Product Change Notification / NTDO-14VTWR800

CCB 4395.001 Initial Notice: Qualification of MMT as additional assembly site for selected Micrel SY5805xAUMG, SY880x3LMG, SY880x3CLMG and SY88xxxALMG device families available in 16L VQFN (3x3x1.00mm) package

CCB 4395.001
Pre and Post Change Summary
PCN # NTDO-14VTWR800

Pre Change UNIS

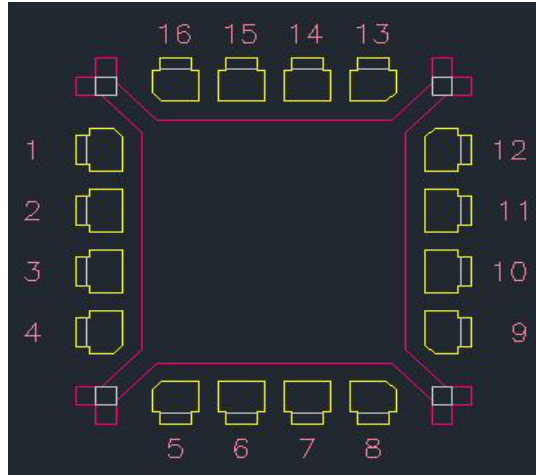
Lead frame Material	C194
Lead frame DAP surface prep	NiPdAu
Lead frame lead-lock	No

Post Change MMT

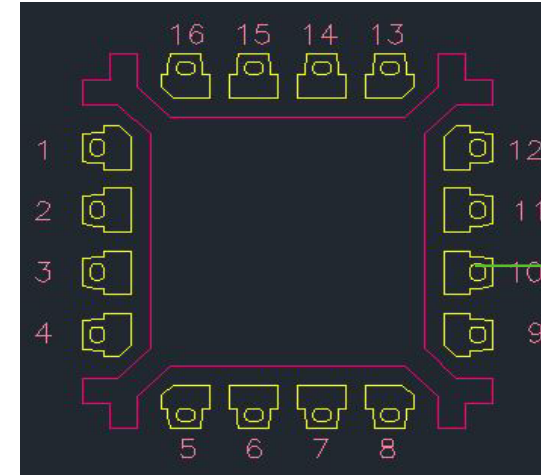
Lead frame Material	C194
Lead frame DAP surface prep	NiPdAu
Lead frame lead-lock	Yes

Note: The lead lock hole fills with mold compound during the assembly process and provides improved protection against moisture penetration around the interface edges between pins and mold compound.
